# COMMITMENT RESOLUTION LETTER #28 DOCKET NO. 72-22 / TAC NO. L22462 PRIVATE FUEL STORAGE FACILITY <u>PRIVATE FUEL STORAGE L.L.C.</u>

In accordance with our March 23, 2000 conference call, Private Fuel Storage (PFS) submits the following resolution to NRC/CNWRA questions and comments regarding geotechnical issues for the Private Fuel Storage Facility (PFSF). The NRC questions/comments are documented below followed by the PFS response.

# Dry Densities of Subsurface Soils at the Site

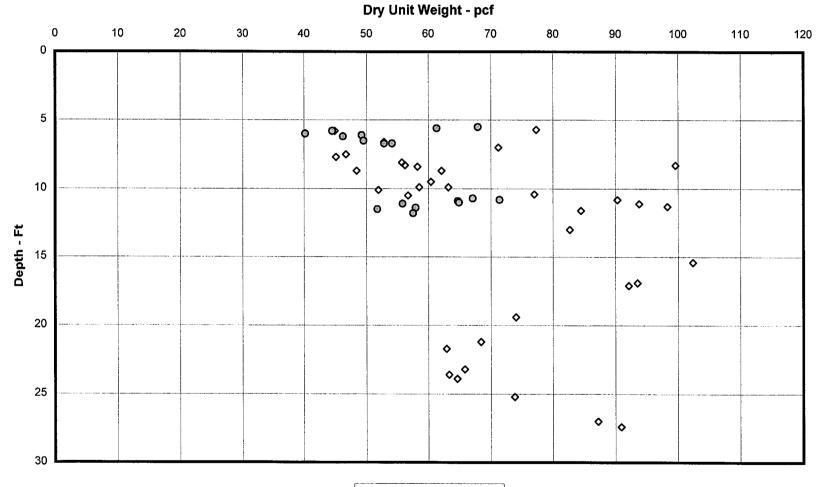
1. Due to the high void ratios of some of the in situ soils and their weakly cemented nature, there is the potential that these soils may be collapsible soils, which could settle dramatically due to wetting caused by the PMF flood or due to vibrations from the design earthquake. PFS should provide more detailed information demonstrating that the in situ soils are not collapsible due to wetting. This response should also include discussion of why the soils will not be wetted from the PMF flood.

The attached plot of dry densities of the subsurface soils at the site illustrates that the upper silty clay/clayey silt layer has the lowest unit weights of the three clayey layers that exist beneath the site. Therefore, the soils in the upper layer are more likely to be collapsible soils than those in the underlying layers. As discussed above, the results of the consolidation tests performed on the upper layer indicate that they are not collapsible; therefore, the soils in the underlying layers are not collapsible, as well.
